RESOURCE CONSERVATION AND RECOVERY ACT FACILITY INVESTIGATION WORK
PLAN ADDENDUM ZONE K CNC CHARLESTON SC
9/1/2000
CH2M HILL

RCRA Facility Investigation Work Plan Addendum -- Zone K Naval Station Annex

Subject: RCRA Facility Investigation Work Plan Addendum, Revision 1
Zone K – Naval Station Annex
Response to SCDHEC Comments
Charleston Naval Complex, North Charleston, South Carolina

CH2M-JONES RESPONSE TO SCDHEC COMMENTS

Figure 2-3
Proposed Vertical Profile Sample Collection Locations
SWMU 161
Charleston Naval Complex Annex - Zone K

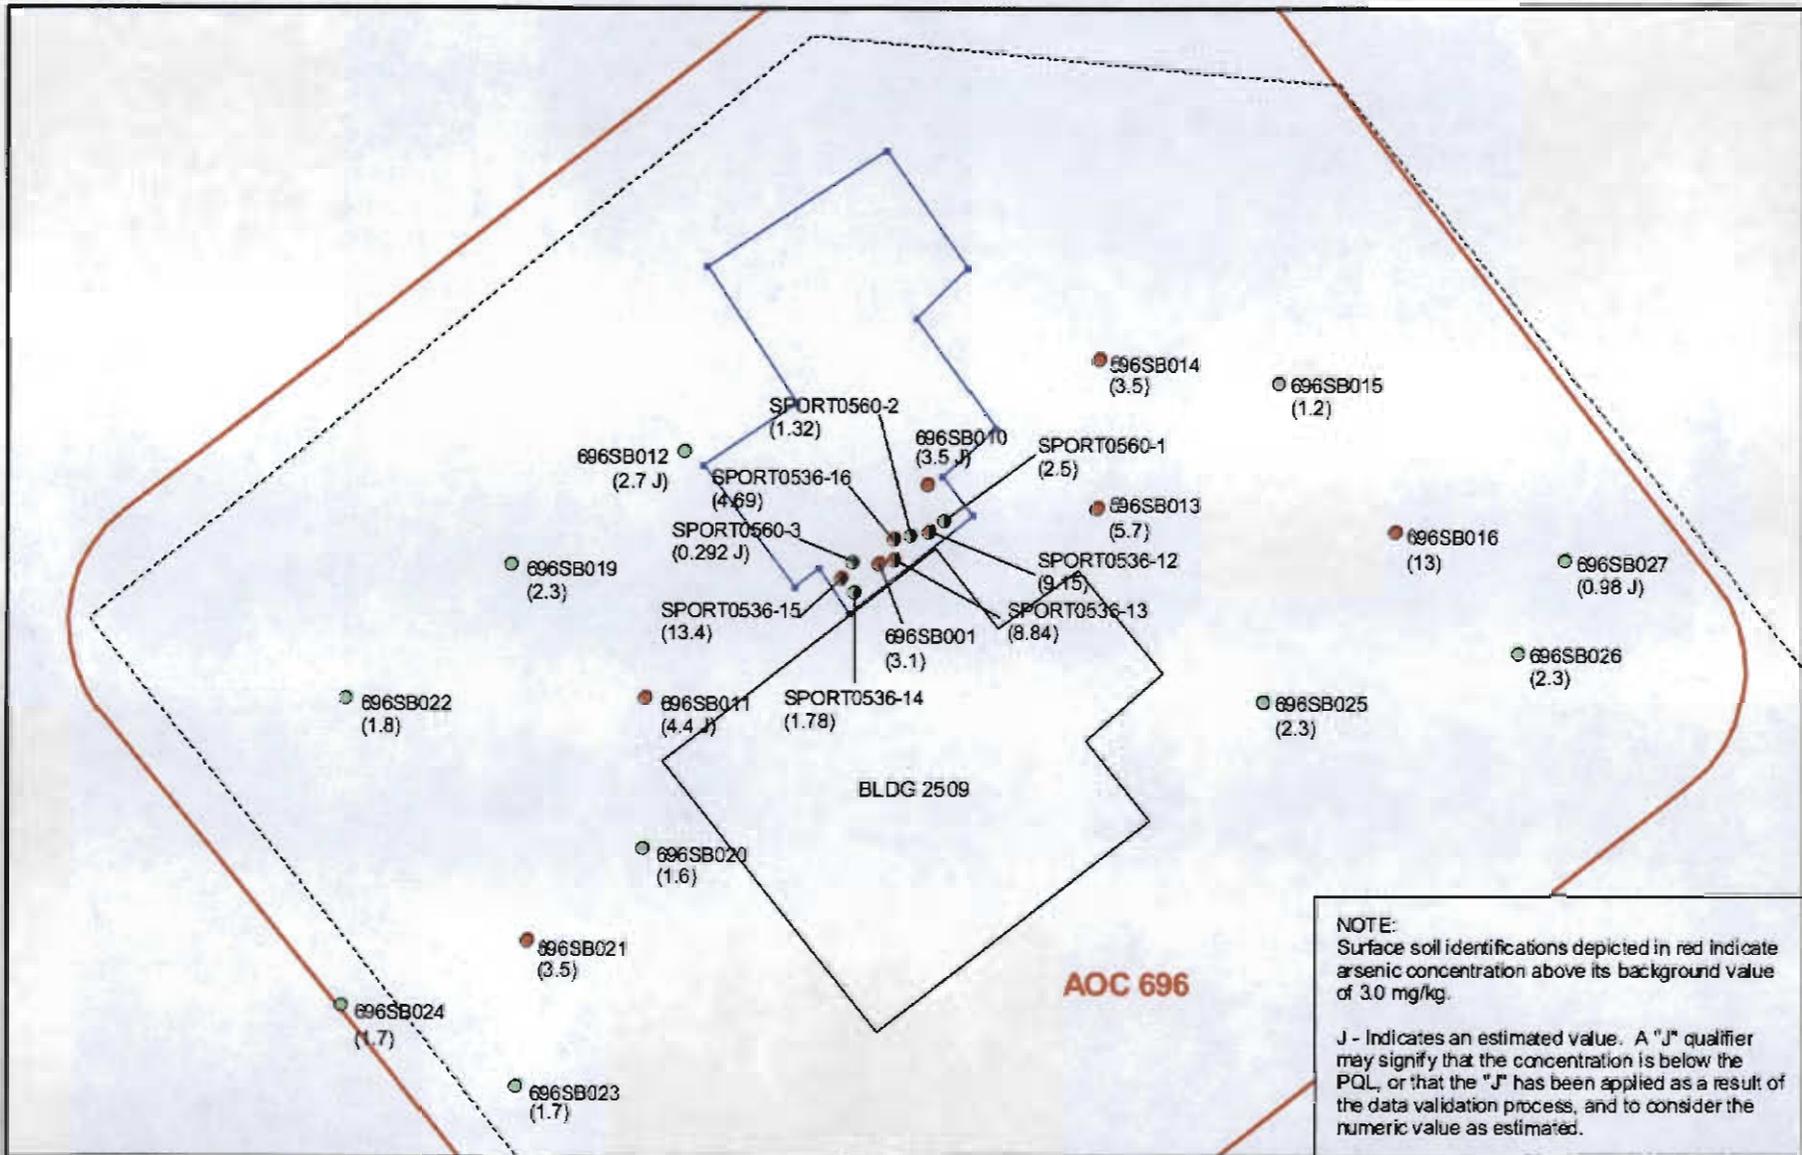
Lines 1-3 recommend not taking sample of the OWS contents as it would not be representative of the life span of the OWS. This is not an acceptable justification. It is considered as a primary source that could have released contamination into the environment through time. The Department recommends that the Navy obtain the referenced sample in order to understand the current use of the OWS and the possibilities of correlation with the past release at this SWMU. Please revise the document accordingly. Please provide adequate figures to illustrate the text description in this section. The Department recommends that the figures used during the Zone K Annex scoping meeting illustrating the known groundwater plume boundaries be included in this work plan. Figures presented in this work plan should also indicate the road names as they are used in the text as landmarks for sample identification. This information will be very useful in understanding the data gaps and rationale for additional field investigation. Please revise the work plan accordingly.

Figure 2-3 presented in this section was used to depict the proposed locations of the vertical profiler points. Since there are no groundwater COCs, the nature and extent of groundwater contaminants were not depicted in this figure. Figure 2-3 will be revised to present the road names within and adjacent to the Annex property boundary.

Figure 2-3 presents the location of the three proposed vertical profiler points downgradient of the OWS.

Figure 2-5
 Nature and Extent of Arsenic in Surface Soil
 AOC 696
 Charleston Naval Complex - Zone K

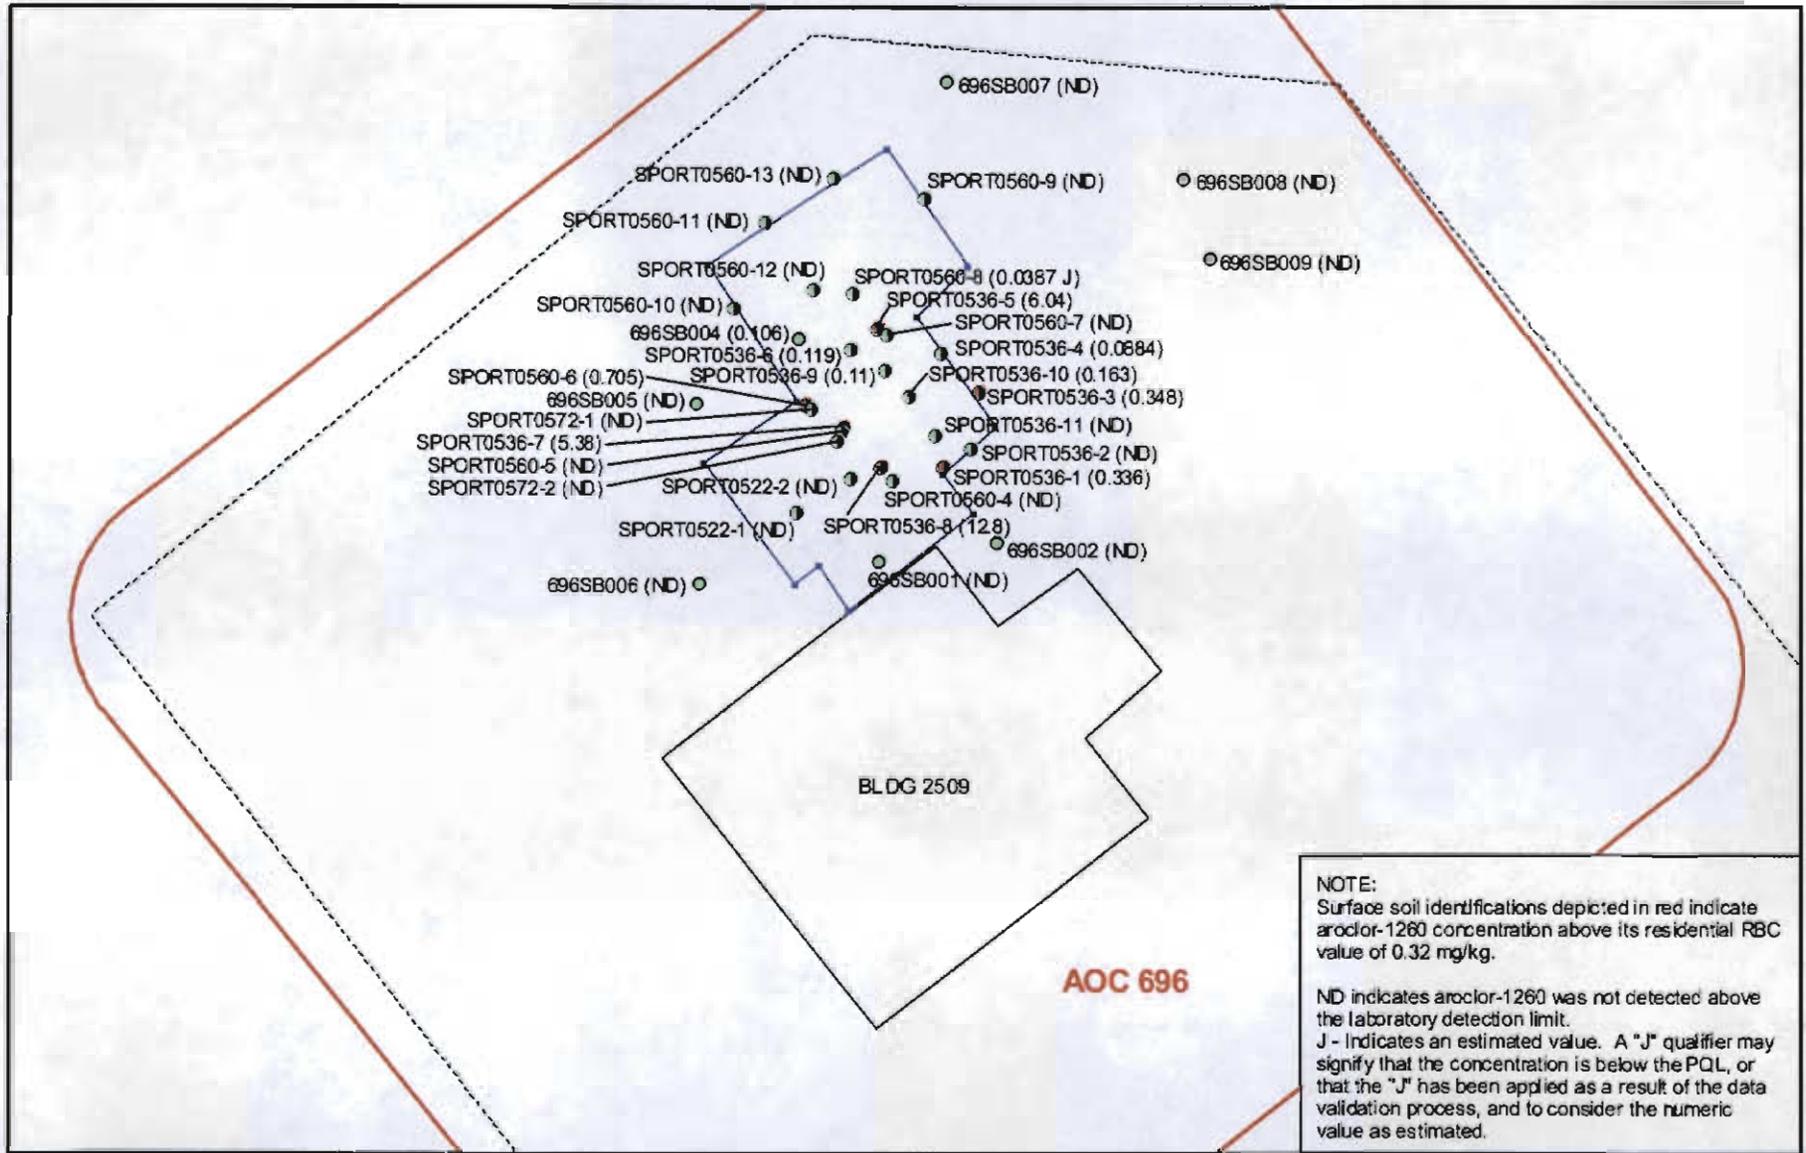
Lines 23-27 indicate that the Navy will conduct the post interim measures evaluation of this site at a later date. Please revise this section to clearly state the RFI report for Zone K Annex will provide current condition of this site and show that the risk in all media are below acceptable levels for justifying the path forward.

“The nature and extent of arsenic and aroclor-1260 in surface soil were characterized by confirmation soil samples collected during the IM and as a result of soil samples collected during the RFI activities. Figures 2-5 and 2-6 present the nature and extent of arsenic delineated to its background concentration of 3.0 mg/kg, and aroclor-1260 defined to its residential RBC value of 0.32 mg/kg, respectively.
